**LEGAL ADVERTISEMENT
HISTORIC PRESERVATION BOARD
CITY OF PORTLAND
Public comments are taken at all meetings.**

HISTORIC PRESERVATION BOARD

HISTORIC PRESERVATION BOARD AGENDA **January 21, 2015 5:00 p.m. - Room 209, Portland City Hall**

PV Array

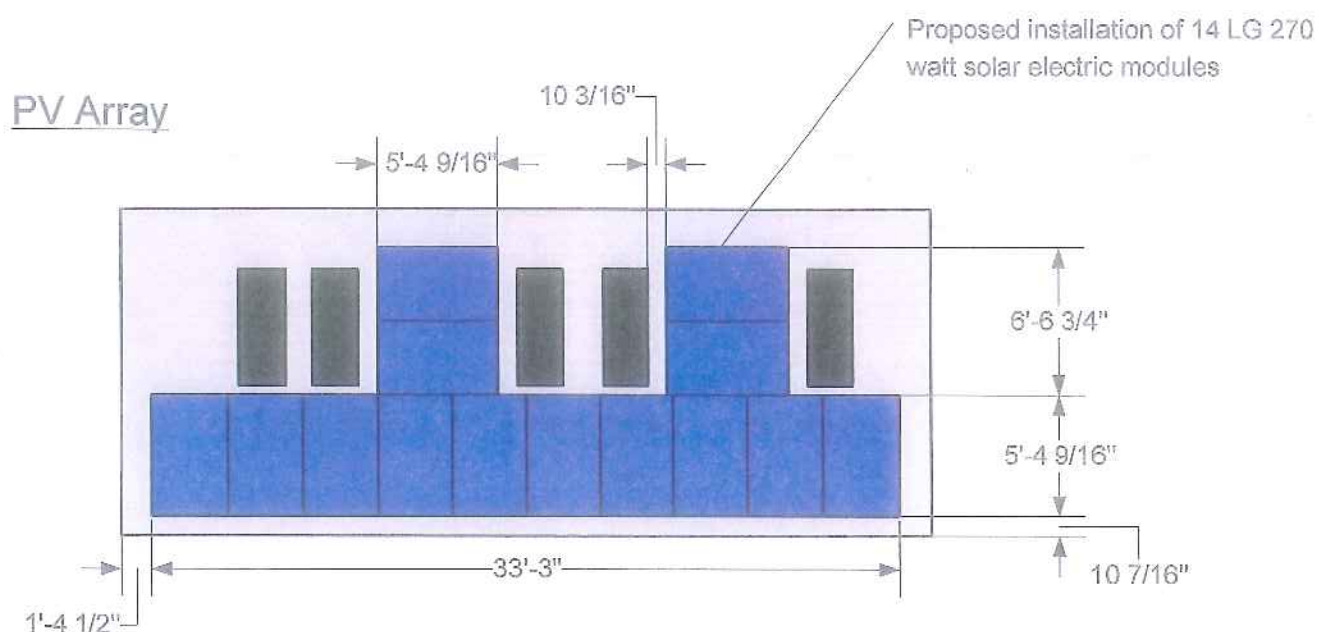
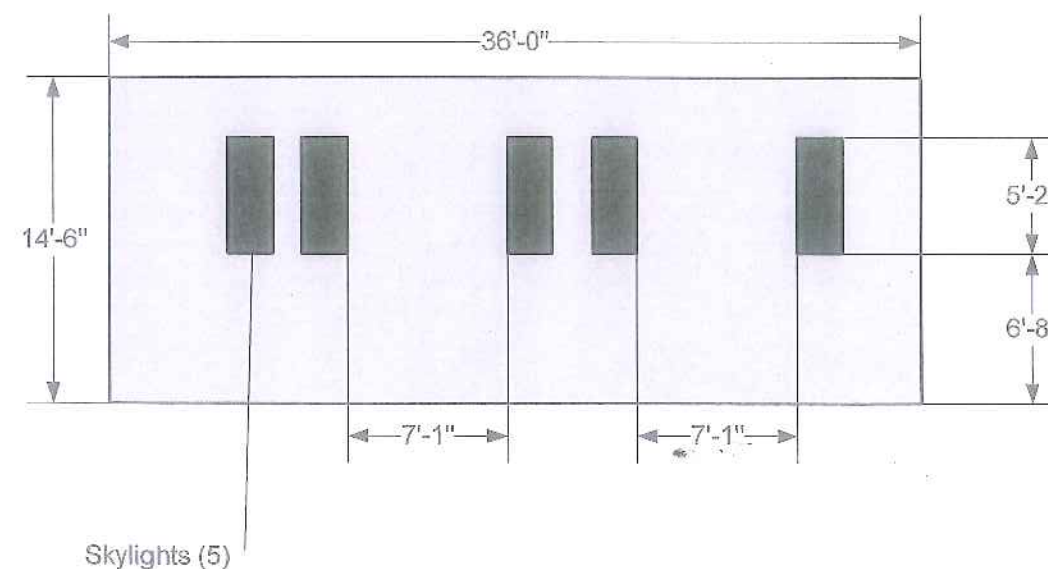
Photos of the roof and the applicants' roof plan illustrate the design of the system fairly well and a conversation with Mr. Bernard clarified some details. The panel modules are a consistent size (39.37" x 65.57") but to increase capacity four are arrayed horizontally (two stacks of two) between the skylights, atop the bottom row of ten. With fourteen panels in the array, Mr. Bernard says the generating capacity of the system would be enough to equal the total electricity demand of both dwelling units.

The Board may want to consider whether a scaled down array may be more appropriate. If the four horizontal modules proposed to be stacked between skylights were eliminated, would the roof appear less cluttered and more ordered? More roofing would be visible, and the row of solar panels would be visually distinct from the row of skylights. Reducing the number of panels by four would reduce the capacity of the system by 28.5%. We don't know whether solar panels were anticipated when the skylights were installed in 2013, but to the extent that it is possible to create a master plan when renovations are planned

Another detail that may be worth mentioning is the possibility of requiring the rooftop conduit to be at least as dark as the color of the roofing on which it sits, or finding a completely invisible route to the house below.

FORE STREET - PROPOSED

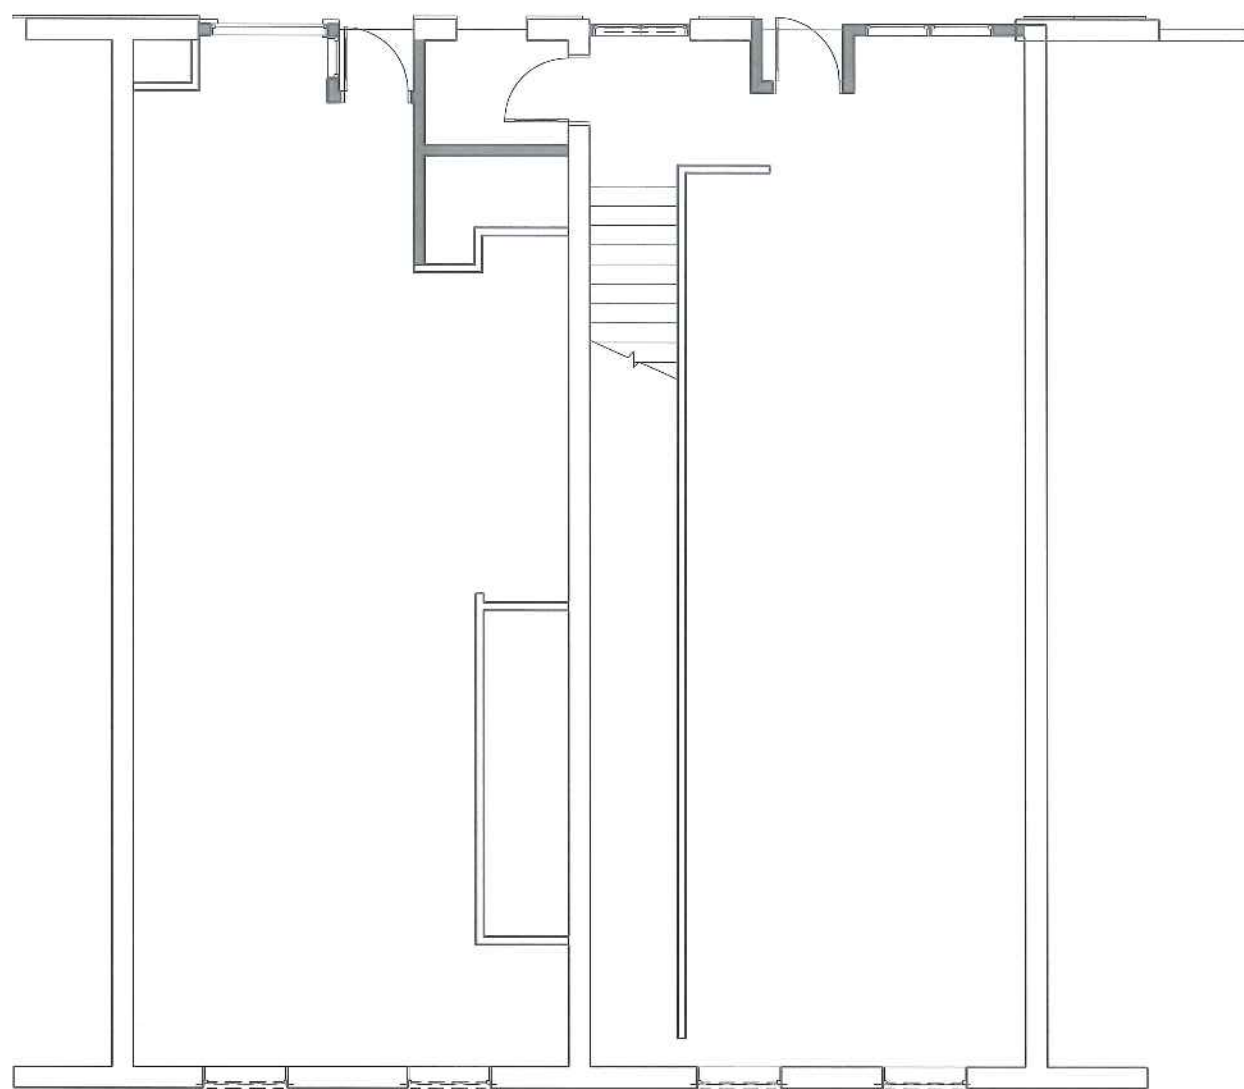
- Repair/repainting of Fore Street storefronts, installation of awnings. The computer-generated image provides general information about the awnings and suggests that they are to be installed within the individual openings, as appropriate. However, specific information regarding fabric, valance style, any plans for including signage on the awnings, etc. has not yet been provided.

1 | WHARF STREET - DEMO ELEVATION
1/4" = 1'-0"

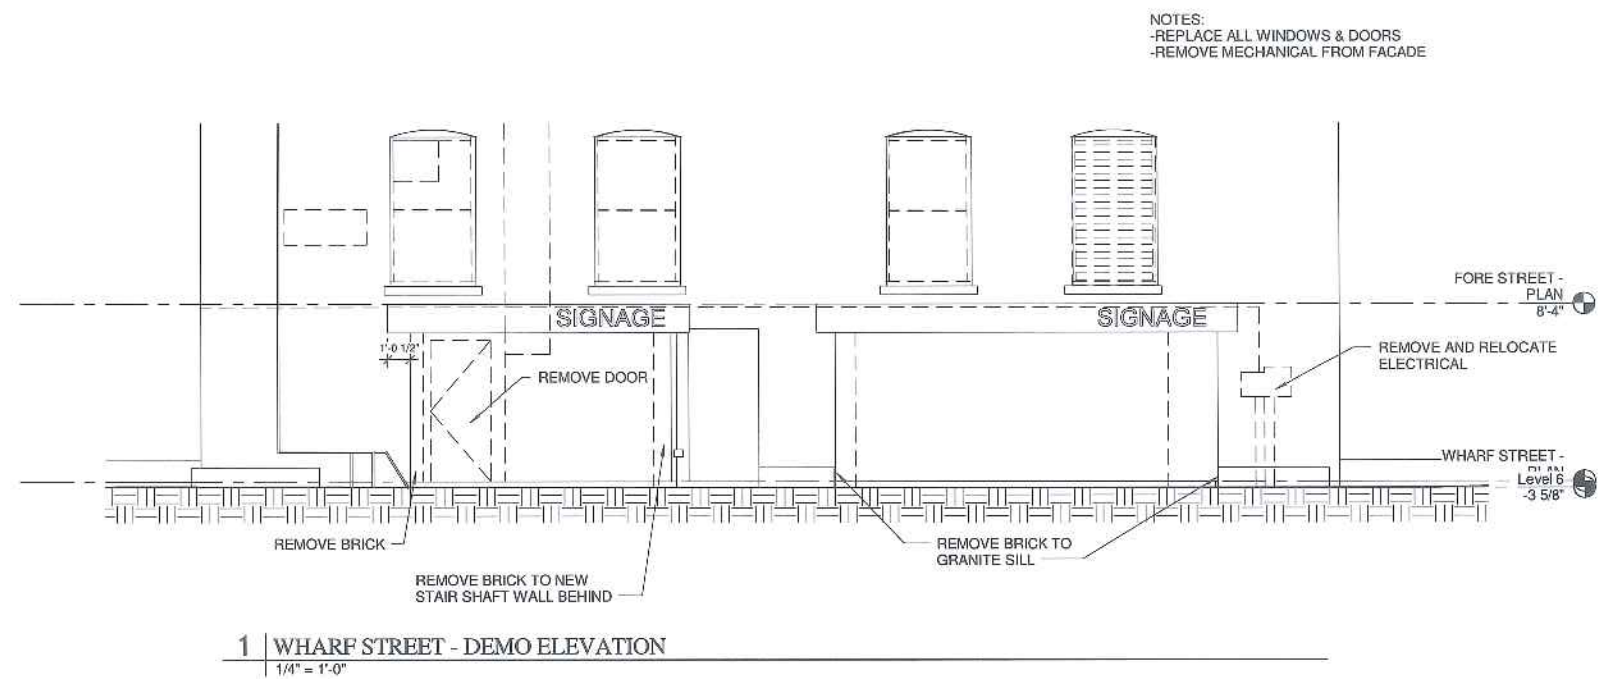
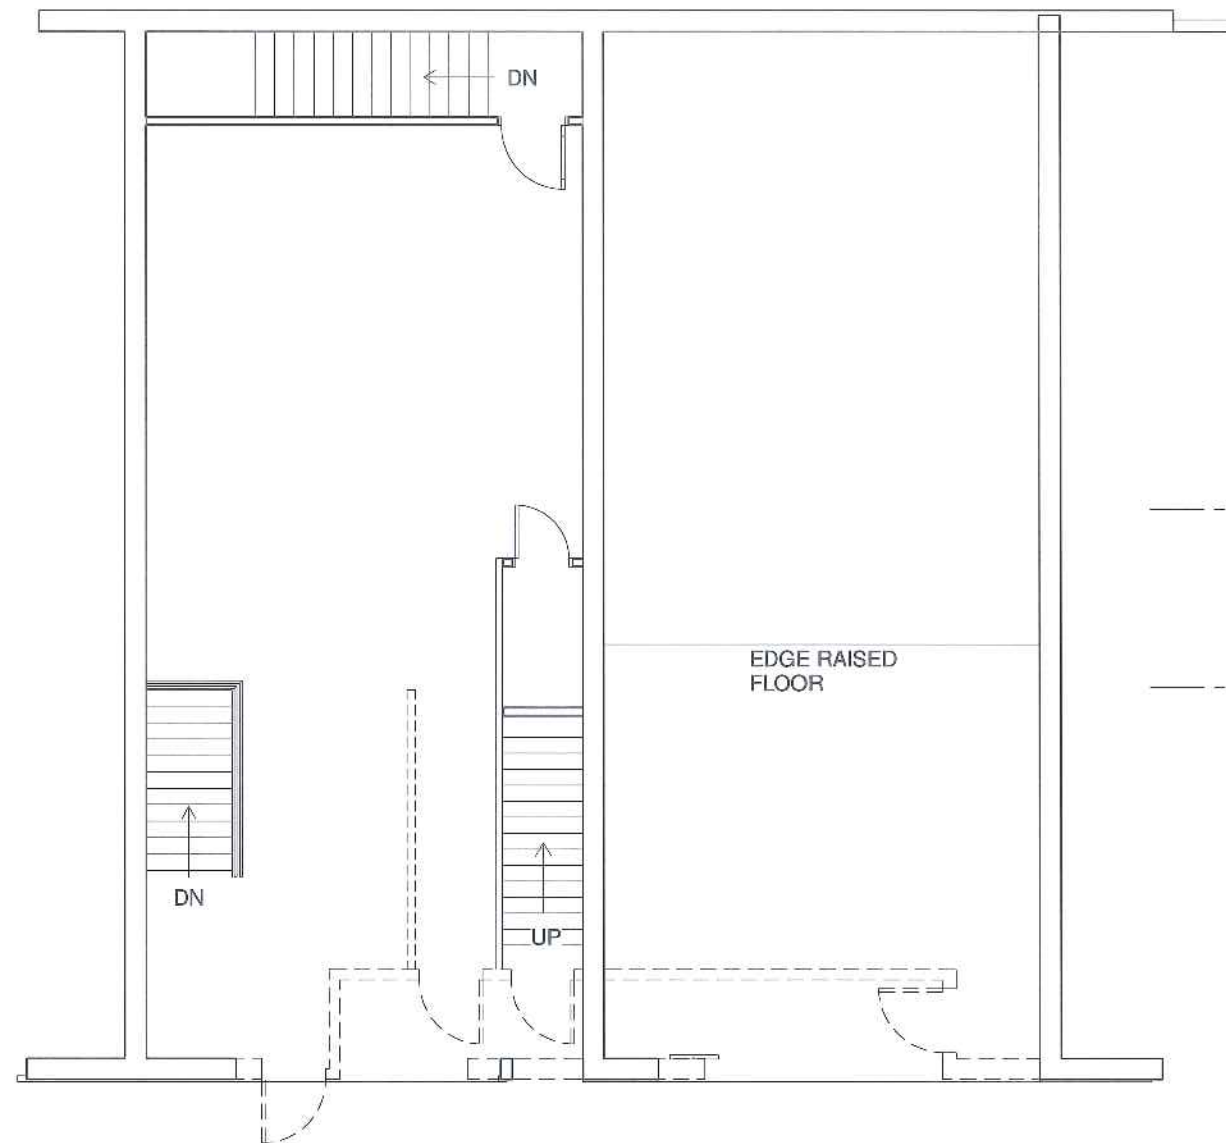
- Comprehensive remodeling of Wharf Street storefronts. Plans call for widening each of the storefront openings (see demo plan for extent of widening) and bringing the storefronts forward to be flush with the building plane. The new storefronts feature large storefront windows above paneled bulkheads and single-light doors. The doors feature a panel at the base, corresponding to the treatment of the storefront windows. Although not clear from the elevations or computer-generated images, staff understands that the applicant proposes to install sign panels over the steel I-beams. Gooseneck lamps are proposed above the sign panels. The applicant is seeking a sign/lighting treatment similar to that of Central Provisions.

PROJECT: House Island - Crested's World
DRAWING TITLE: Main Floor
OWNER APPROVAL:

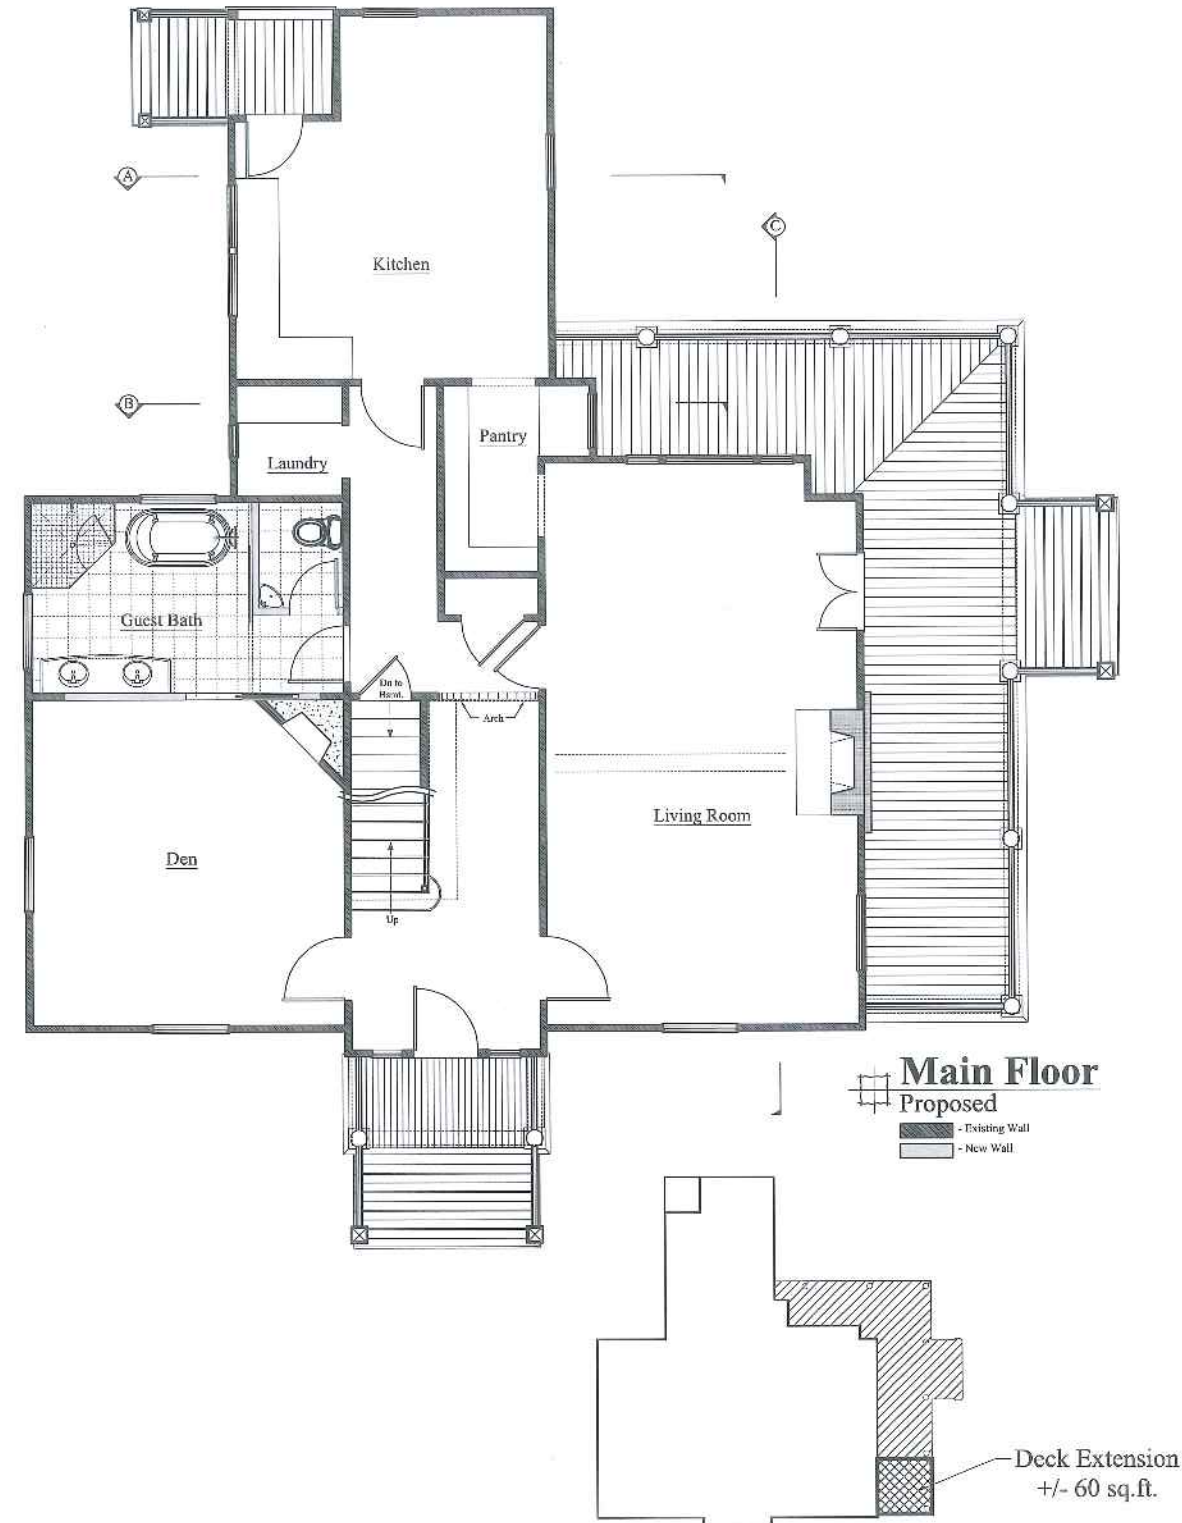
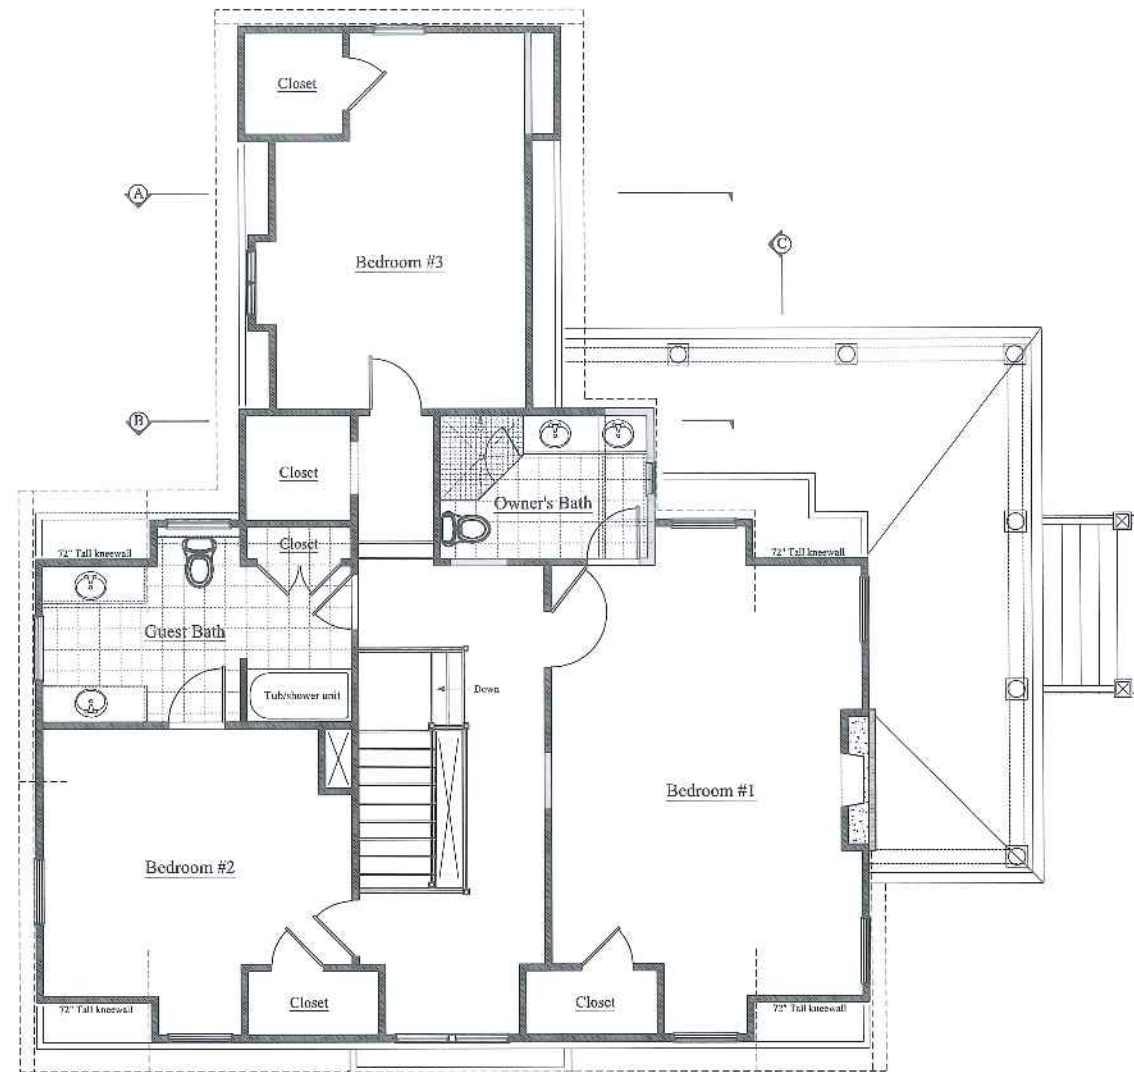
You will find a revised drawing of the floor plan that shows the movement of the back kitchen door. The need for this change has to do with the flow and functionality of the kitchen. The corner of the existing door placement is needed for the location of the refrigerator. It also allows for entrance into a "mudroom" area with a coat closet versus to the entrance directly into the kitchen.

**Second Floor
Proposed**

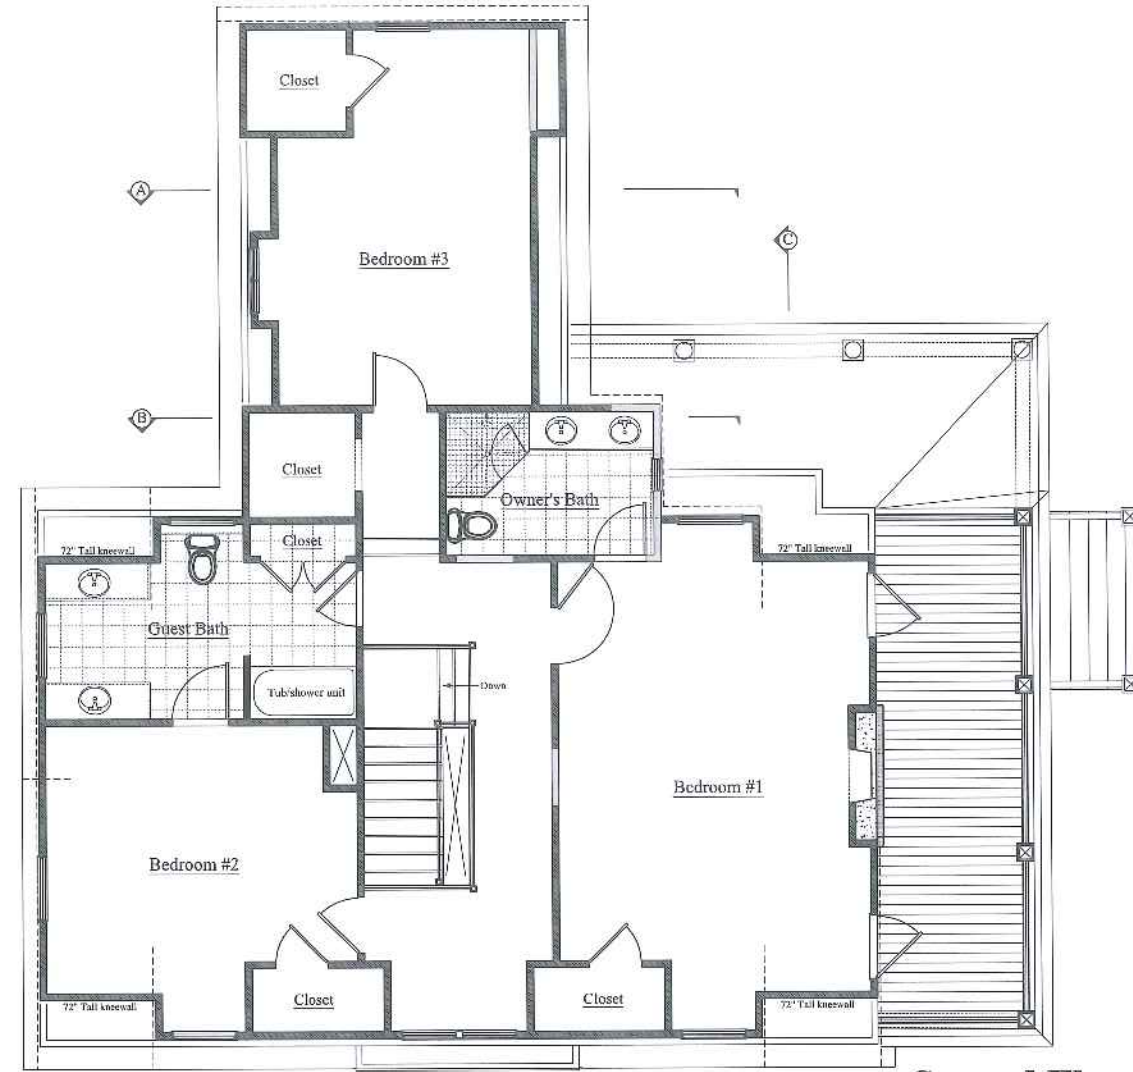
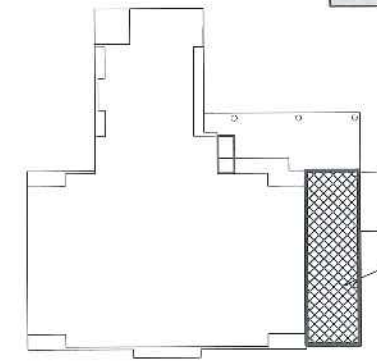
The project calls for extending the existing porch toward the front corner of the house, stopping just shy of the corner to allow the curving sweep of the roof edge to be read. As proposed, a second level to the porch would be added on the side elevation elevation only (it would not wrap the southeast corner as the first story porch does.) All details of the first floor porch would be replicated on the second floor. The project also calls for the replacement of the two second story windows flanking the chimney with pairs of French doors. The header heights would be maintained with the new doors.

Its been a little while since we last spoke about this, but based on the last conversation, we extended the porch to just shy of the corner as not to lose the sweep that exists on the front overhang, The upper deck would be accessible from the master bedroom suite through 2 French doors, one on each side of the fireplace. The doors would replace and match the header heights of the existing windows. Nothing changes with the construction of the lower porch other than it's extension to the corner.
